Deer Ridge Subdivision

Eastern Connecticut Environmental Review Team Report

Environmental Review Team Report

**for the
Conservation Commission
Westbrook, Connecticut**

Figure 3.

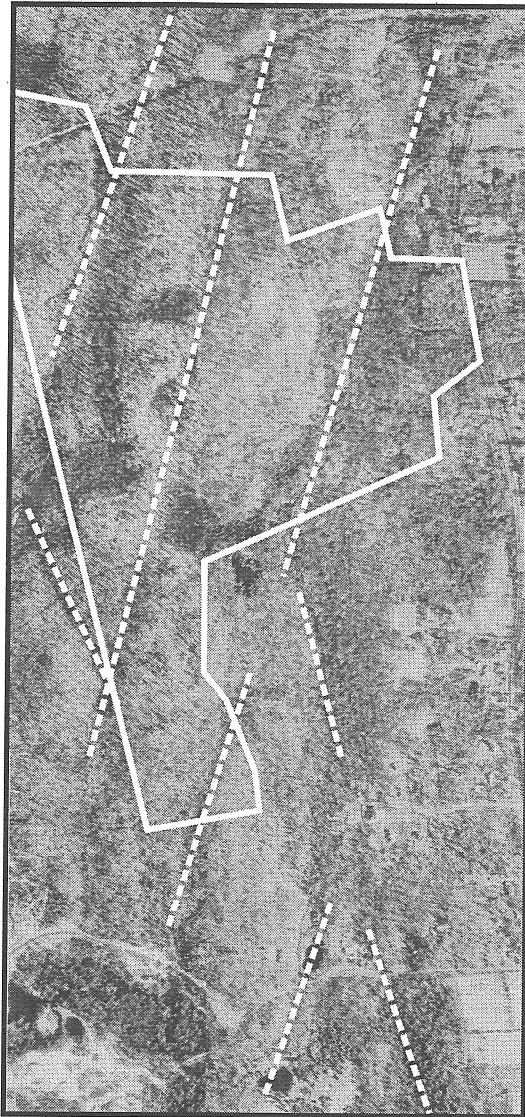
The Monson Gneiss, a rather homogeneous, light gray, feldspar-quartz-biotite-hornblende gneiss, interlayered with amphibolite and granite underlies the site. The rock is not conspicuously rusty weathering, which suggests that high levels of dissolved iron will not be a problem in domestic wells. In outcrop vertical NNE joints and fractures parallel to the prominent shallow dipping foliation are common. Bedrock wells should be quite productive. The highest yielding wells will no doubt be sited in the highly fractured NNE ravines delineated in Figure 3.
